Dart Aerospace Ltd. Date: Monday, 11/6/2006 2:40:01 PM User: Kim Johnston **Process Sheet** : 206/OH-58 SADDLE, INBOARD, LEFT SIDE **Drawing Name** : CU-DAR001 Dart Helicopters Services Customer : 29344 Job Number : 10833 **Estimate Number** ·NIA : D29331 Part Number P.O. Number S.O. No. : HM : D2933 REV B **Drawing Number** : 11/6/2006 This Issue : NC **Project Number** : N/A Prsht Rev. : NA Туре : MACHINED PARTS **Drawing Revision** First Issue : 29232 Material **Previous Run** : 11/24/2006 Qtv: 8 Um: **Due Date** Written By **Checked & Approved By** New DWG rev (mpp 2069) EC : Est: Comment **Additional Product** Job Number: Description: Machine Or Operation: Seq. #: 7075-T7351 2X6X6.25 D6101001 1.0 Comment: Qty.: 1.0000 Each(s)/Unit Total: 8.0000 Each(s) Issue material from stock: 7075-T7351 QQ-A-250/12 Cut Size 2.0 x 6.25 X 6.00 Grain Along Long 6.00 Length Batch No: B25343 HAAS CNC VERTICAL MACHINING #1 2.0 HAAS1 Comment: HAAS CNC VERTICAL MACHINING #1 Program part number and batch number. 1-Inspect part number and batch number are programmed correctly. 2-Machine Step No 1 of Folio and visually inspect as per dwg D2933 & attached Dimension Sheet 3-Machine Step No 2 of Folio an

DART AEROSPACE LTD	Work Order:	29344
Description: 206 Saddle, Inboard, Left side	Part Number:	D2933-1
Inspection Dwg: D2933 Rev. B		Page 1 of 1

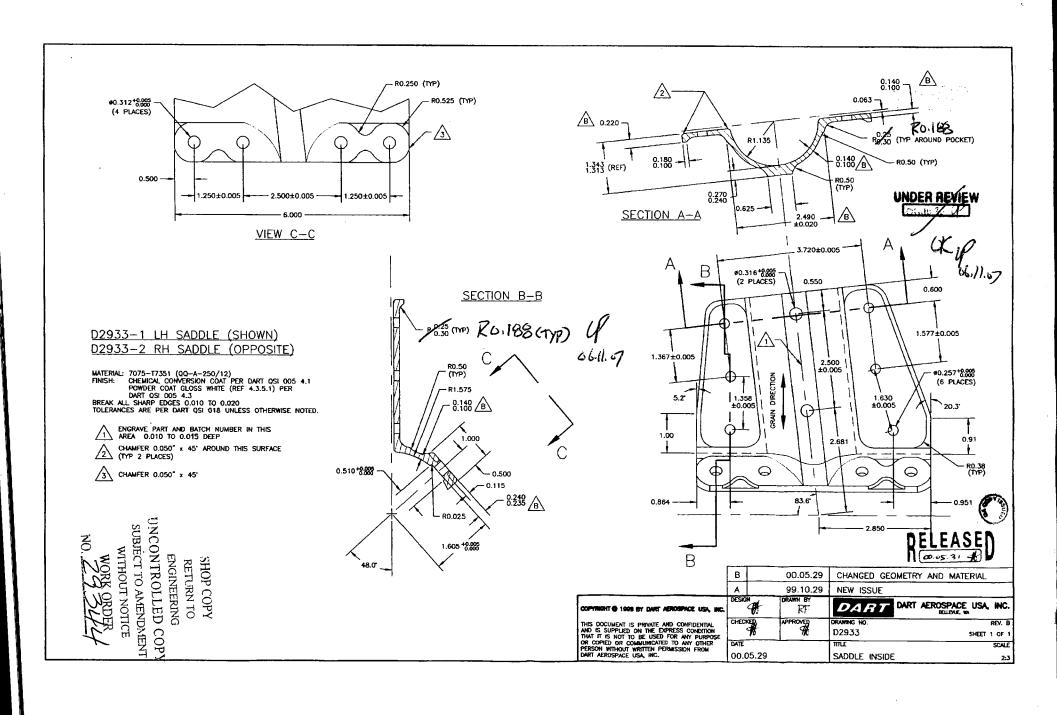
On attach saddle drawing, according to Eric the marked-up radius that reads 0.30 and 0.25, should be 0.188 since the tooling has been changed long time ago, and apparently they have been machining those radiuses to 0.188 for a while. Do you see a problem with that? if not I will go ahead and change the drawing to reflect the changes.

Change the drawings. I guess we will also change the 0.313 crosstube hole dimensions as well. See D2661 to D2668 as well as D2932 to D2933.
